KEY. Refer to MLM letter dated 24.03.06

drawing A. NURSING HOME EXTENSION
FIRST FLOOR PLAN
GENERAL ARRANGEMENT

project ADDERLEY HOUSE
LONG SUTTON

drw no 4161 GA. 3 rev E

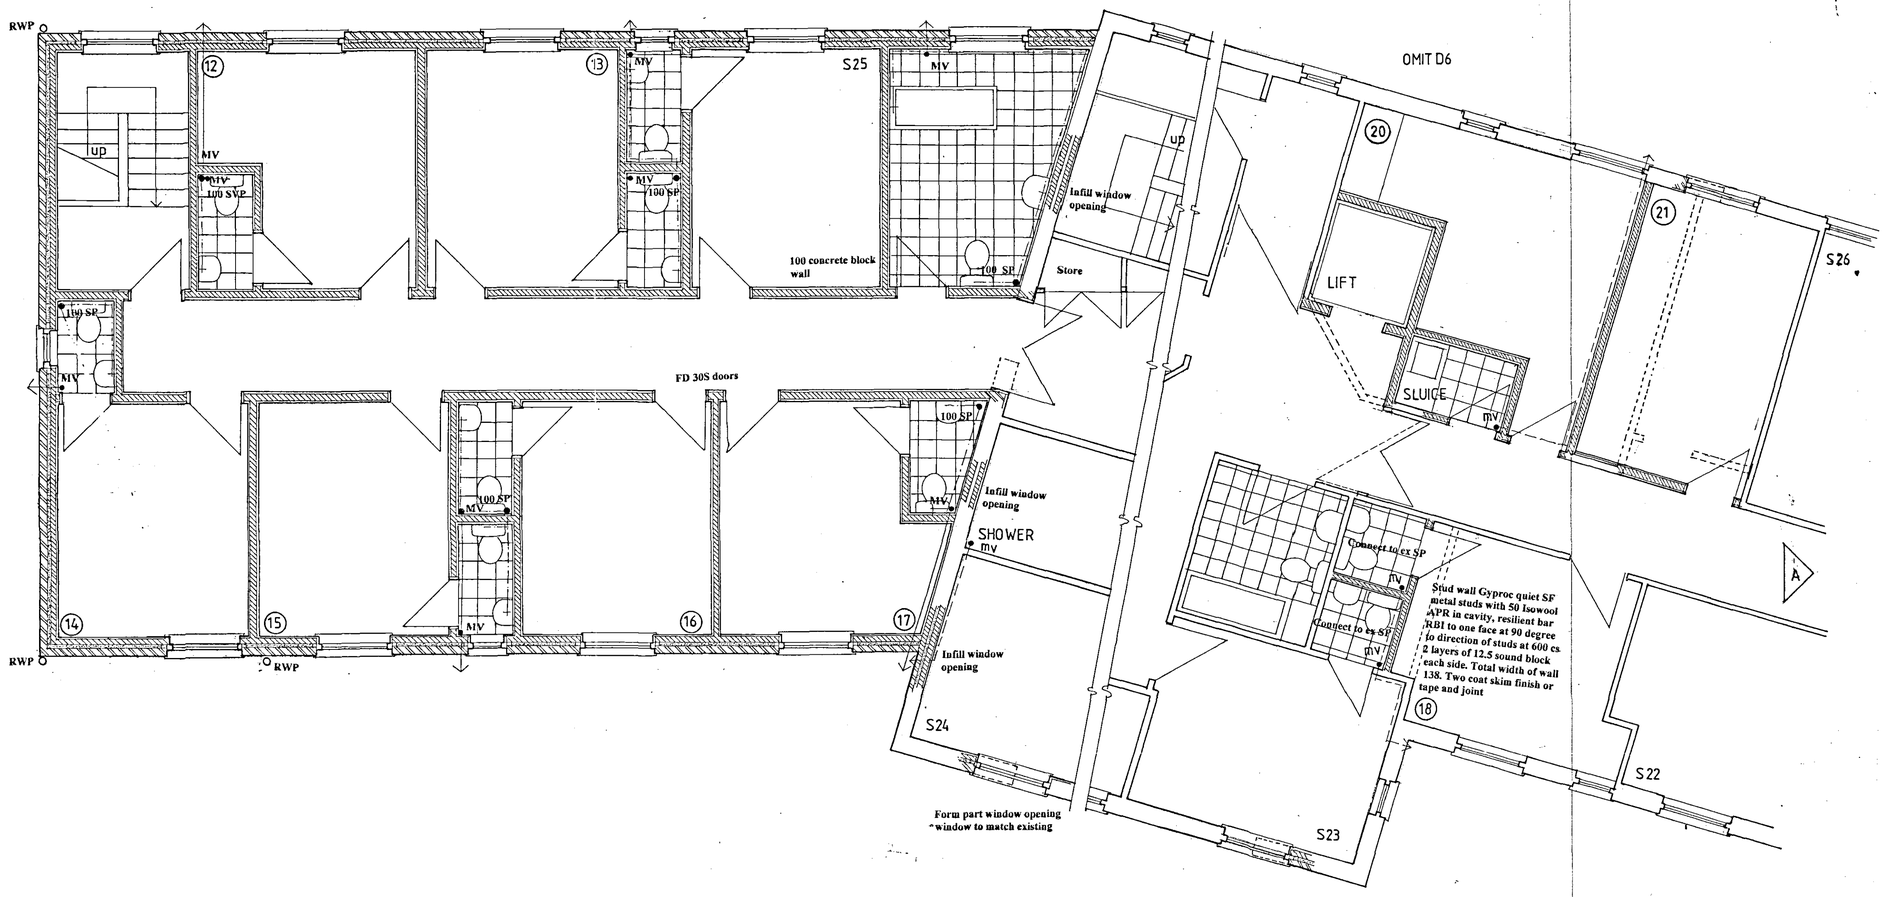
(2) Cavity barriers to be provided in roof space to ensure no cavity exceeds 20m in any one direction
(3) New double doors across corridors to be FD30S fire doors
(14) Rooms 18 and 23, fire resistance will be required to any new drainage passing through floors
(15) New drainage to be reassessed on site
(17) Access statements also to provide statement why access is not provided to first floor office and training room
(18) Full height glazing to corridor link to have adequate manifestations at 2 levels
